COUNTY OF FLUVANNA, VIRGINIA
(IFB) #2020-01
FLUVANNA COUNTY – BURN BUILDING CONSTRUCTION

ADDENDUM # 3:

Reference – Invitation for Bid: IFB #2020-01
Title of Request for Proposal: FLUVANNA COUNTY – BURN BUILDING CONSTRUCTION
Issue Date: July 16, 2020
Bid Due Date and Time: July 29, 2020 at 2pm

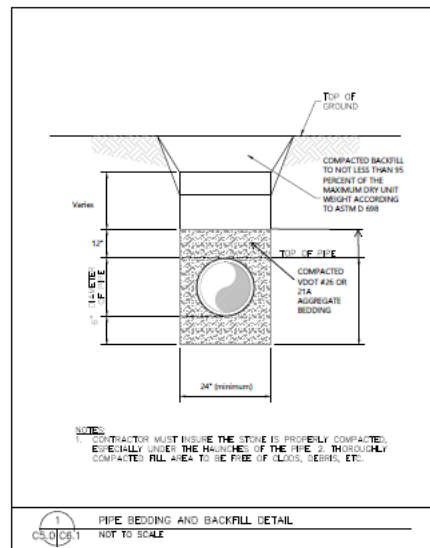
13. The waterline detail does not show any stone bedding or stone backfill. Will any stone bedding or stone backfill be required for the waterline? If yes please update the detail with the correct stone types and depths.
- Refer to the detail below.
